# Attachment A: Issue No 1 - Adequacy of view assessment

# Attachment B: Issue No. 2 - Built form massing

# Attachment C: Issue No. 3 - Podium facade design quality

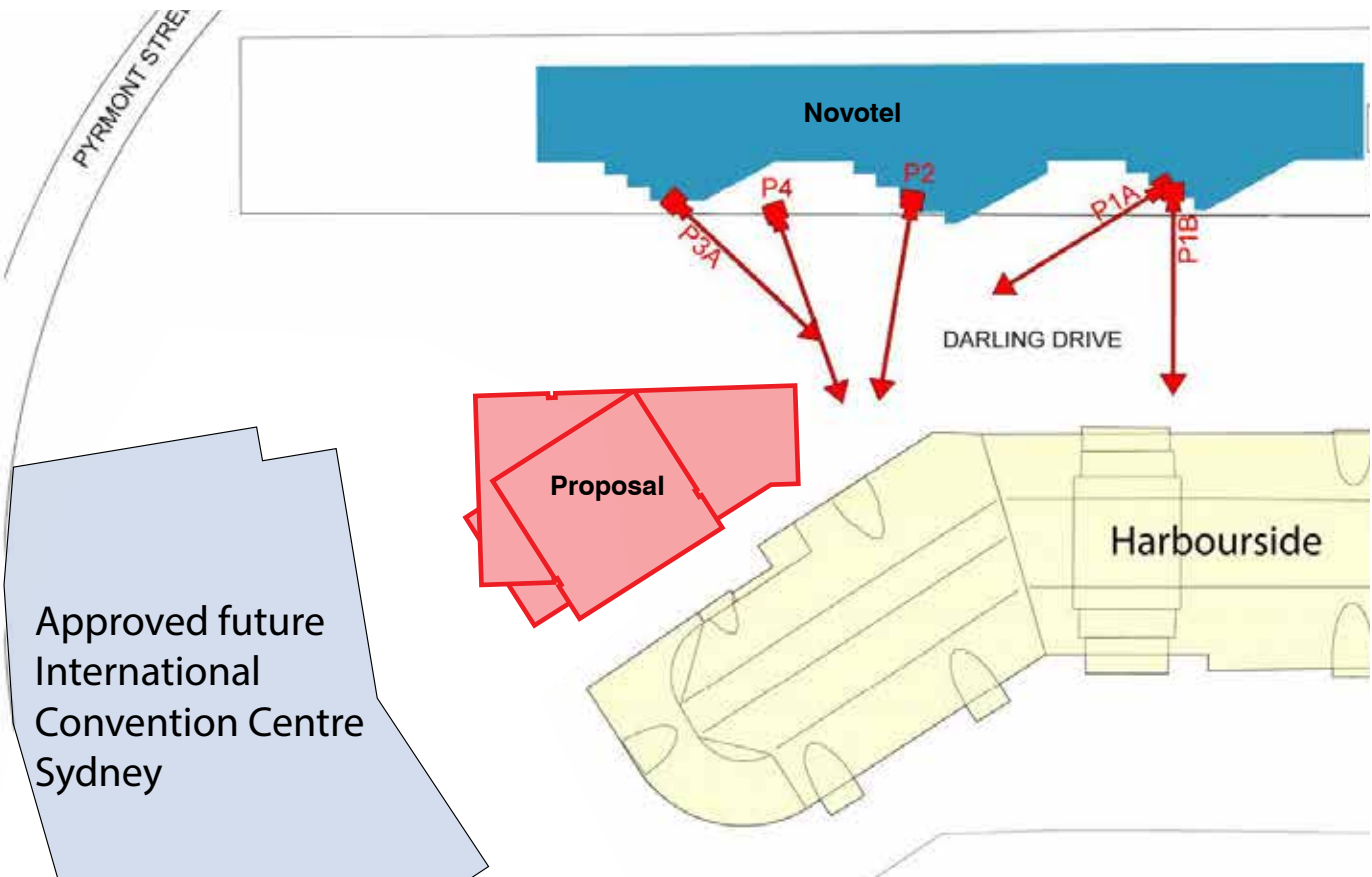
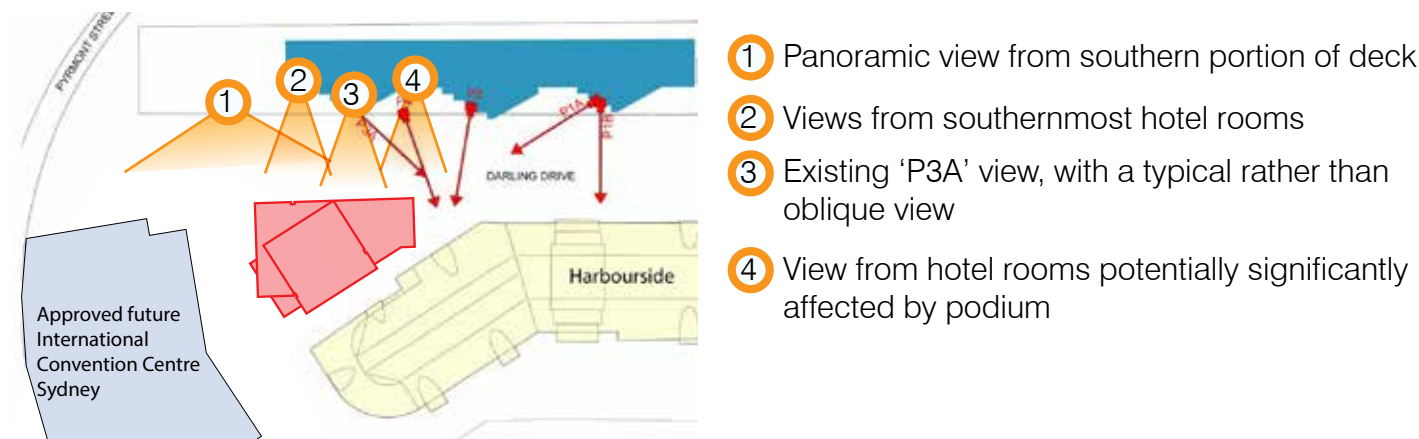
The View and Visual Impact Assessment document (VVIA) by JBA, submitted with the application:

- Selects views which are focussed away from the proposal, **minimising its apparent visual impact** (see diagram adjacent).
- Uses oblique views which are **not representative of actual views obtained** from the Novotel rooms (see diagram adjacent and following pages).

- Significantly **under represents the loss of views** for the most affected parts of the proposal, stating that “this encroachment is only in a small portion of the south western field of view and is not considered to be significant” (page 24, VVIA) for the most affected views tested, where in fact many rooms within the southern portion of the proposal will experience a complete loss of the typical existing aspect (see following pages). A large number of Novotel rooms will suffer a loss of aspect due to the proposed tower and/or podium, particularly though the loss of important view elements such as water views and the southern edge of Cockle Bay. Testing of actual likely views for many of the most affected views has not been undertaken by the applicant however it is likely that around 30-40% of the east-facing Novotel rooms will have their views significantly affected by development and around 10-15% of east facing rooms are likely to experience a complete or near-complete loss of their existing aspect from a typical location within the rooms.

Views selected for analysis within the VVIA, shown together with the proposal and approved Convention Centre. This diagram shows that views selected in the VVIA are directed away from the proposal. These are not the actual views from these rooms, as shown overleaf (diagram adapted from extracts from VVIA document).

The VVIA should test a range of potentially significantly affected views across the southern frontage of the Novotel and its deck, including those described in the following diagram. Views from rooms tested should be from the centre of the rooms, including the frame of the windows.

## Demonstration of existing view from Hotel window and actual view loss (1/3)

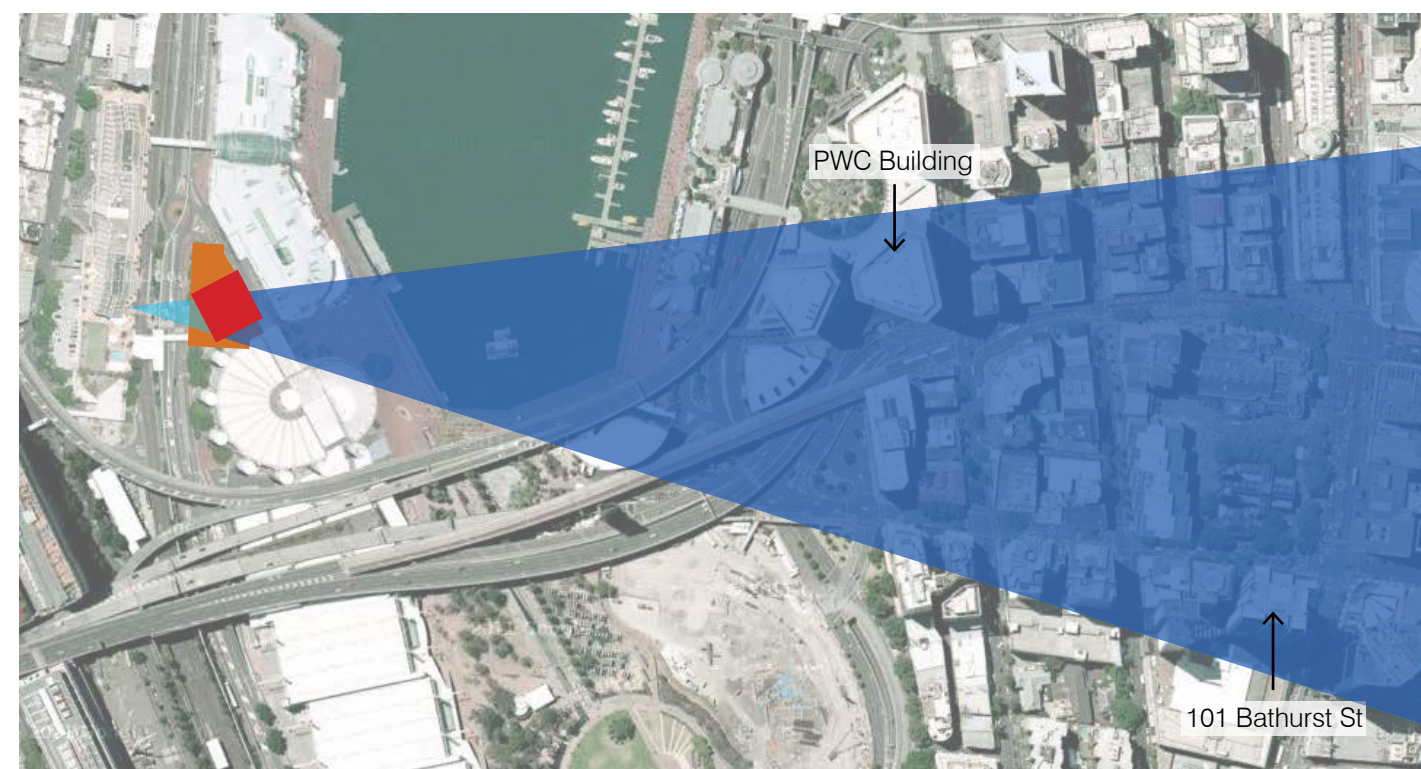
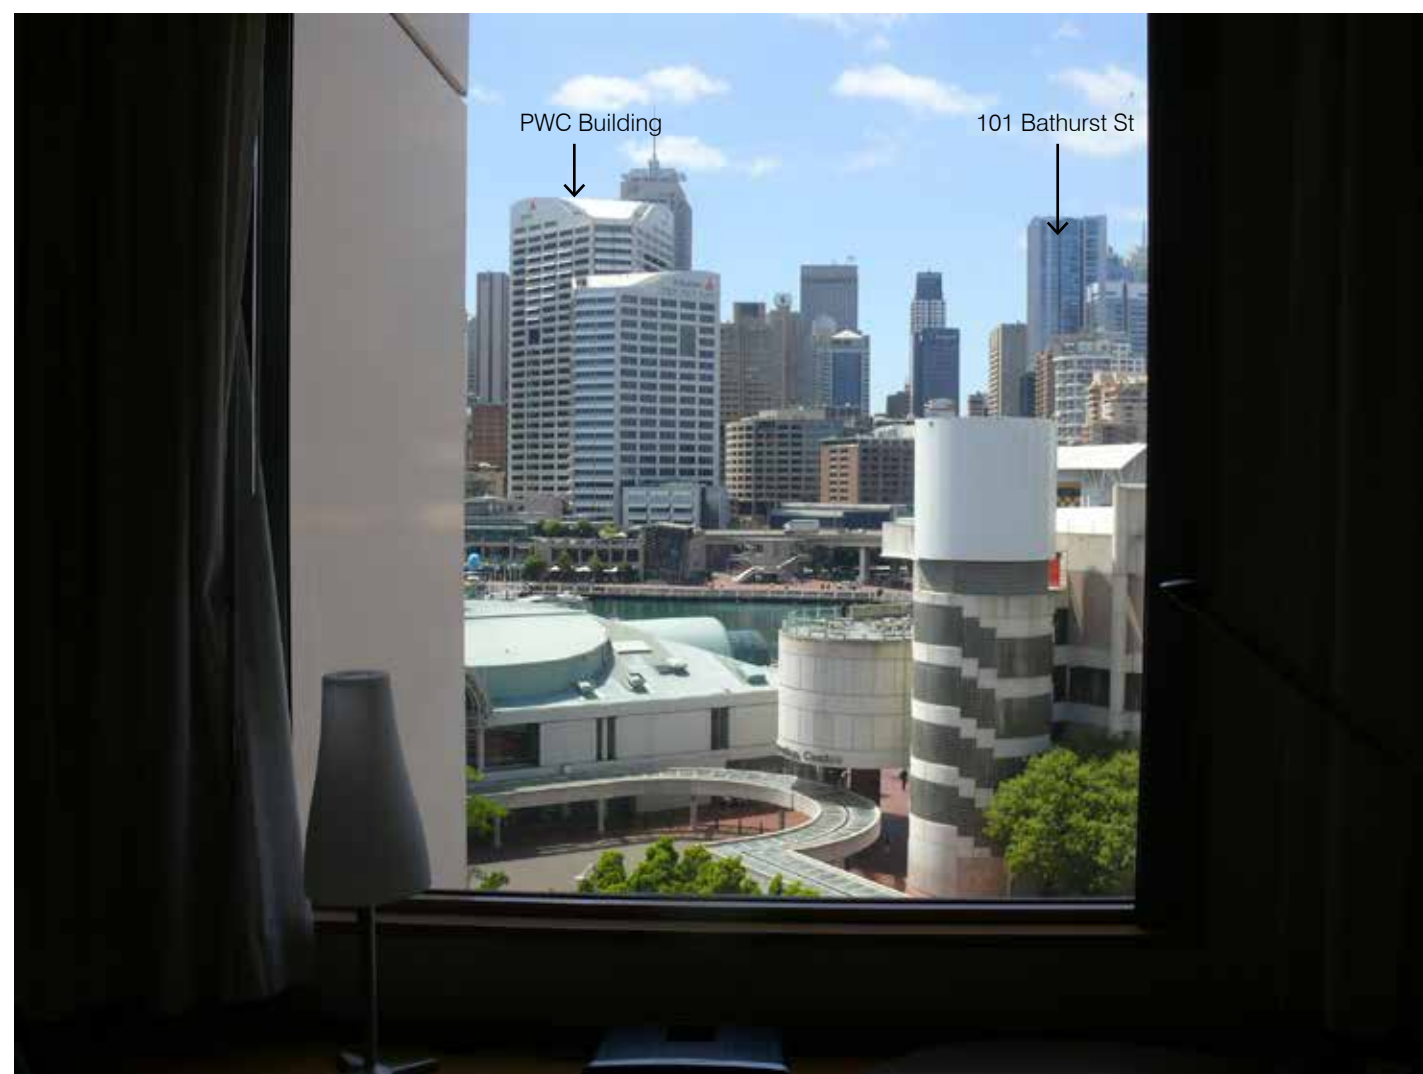
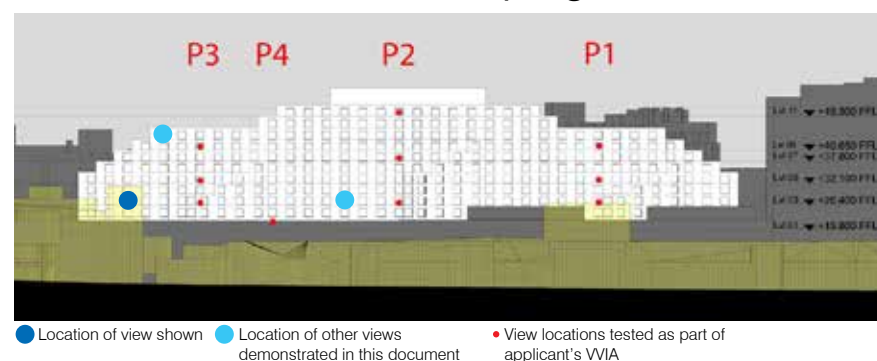
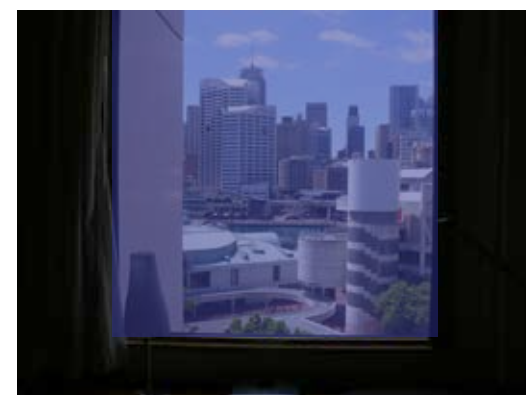
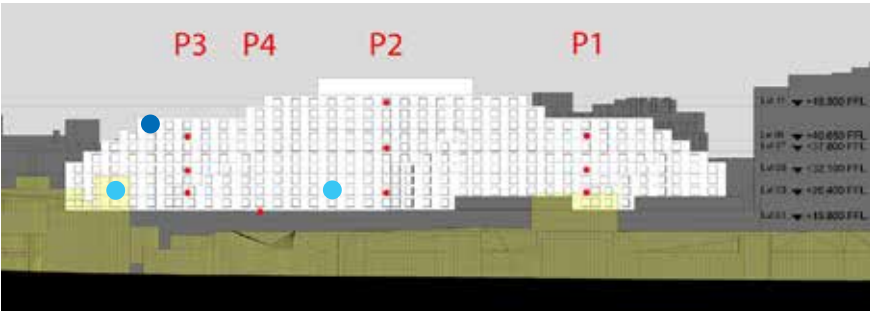
This plan shows the approximate impact of the proposal on the existing view shown to the left.

The existing view demonstrated from this room will experience:

- **Complete loss of the existing view** including water views of Cockle Bay and elements of the iconic Sydney CBD skyline.
- A consequent **loss of existing daylight**.
- Replacing the existing view will be a sheer glass facade of **hotel windows facing the room**.

100% of the view is lost

Demonstration of existing view from Hotel window and actual view loss (2/3)

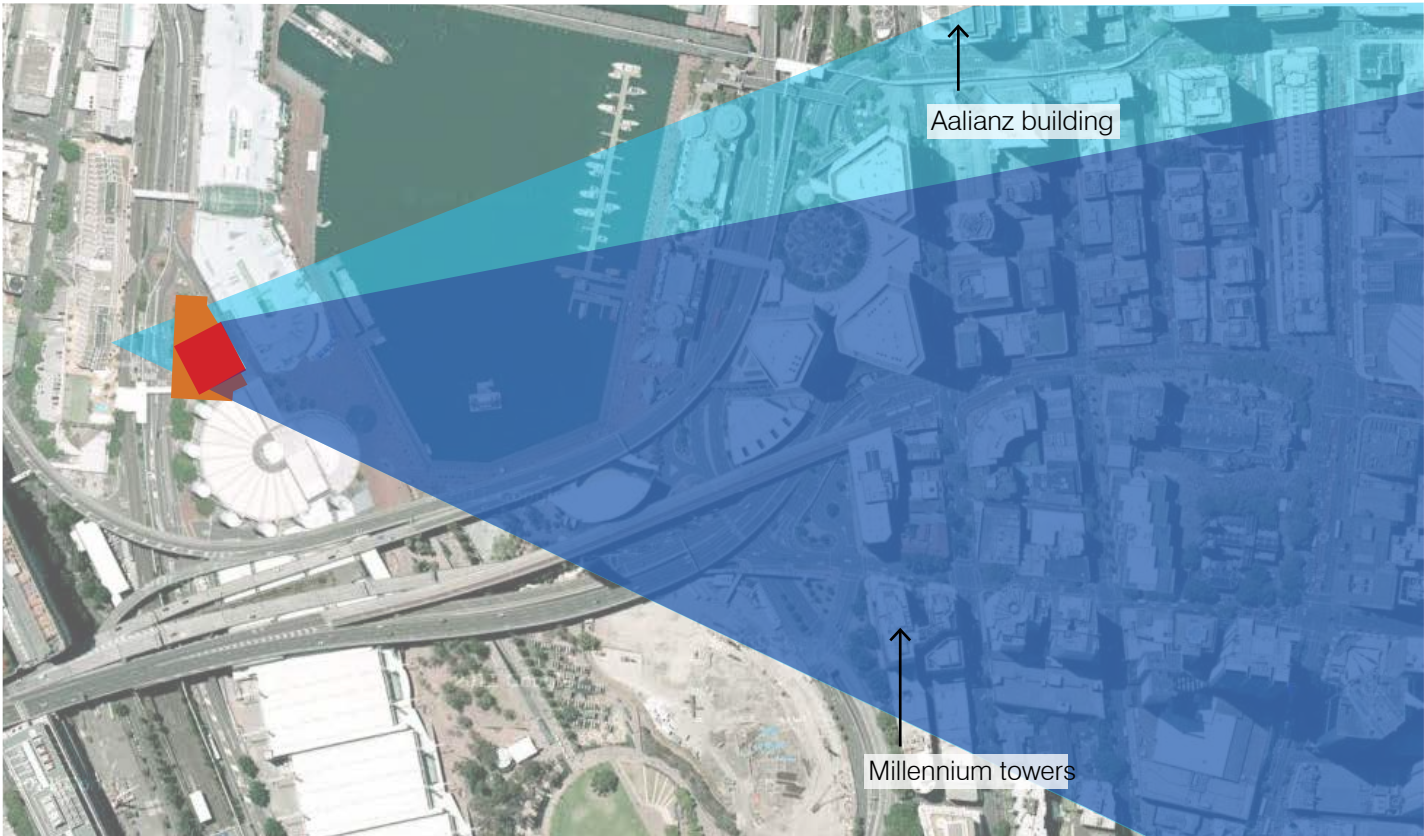
This plan shows the approximate impact of the proposal on the existing view shown to the left.

The existing view demonstrated from this room will experience:

- An approximate **80% loss of the existing aspect**
- A consequent **loss of existing daylight**.
- **Loss of the focal point of the existing view**, the southern end of Cockle Bay.
- Significant **loss of the existing water views** and iconic elements of the CBD skyline.
- Replacing the existing view will be a sheer glass facade of **hotel windows facing the room**.
